RP170 Power connector incorrect gender on Terrapro

Some Mack Terrapro trucks were built with an incorrect connector for the Bodylink RP170 power connection. A jumper is available to change the connection to the correct gender.

Repair Procedure:

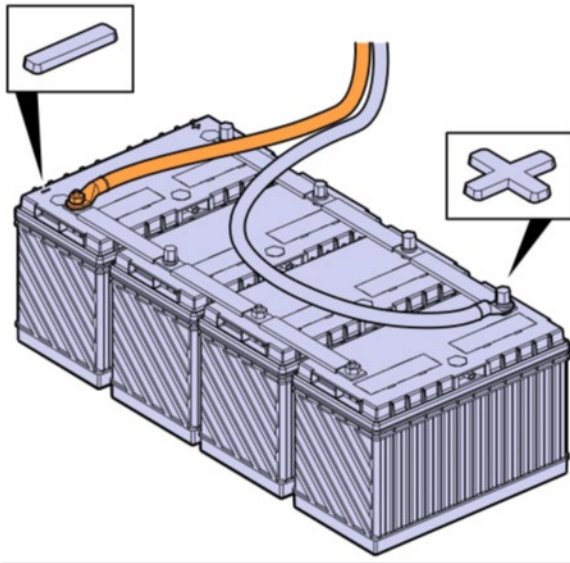
1. Locate clean power connector

Add jumper PN 23630007, fold back extra length and secure to harness.

2. Add jumper PN 23630007
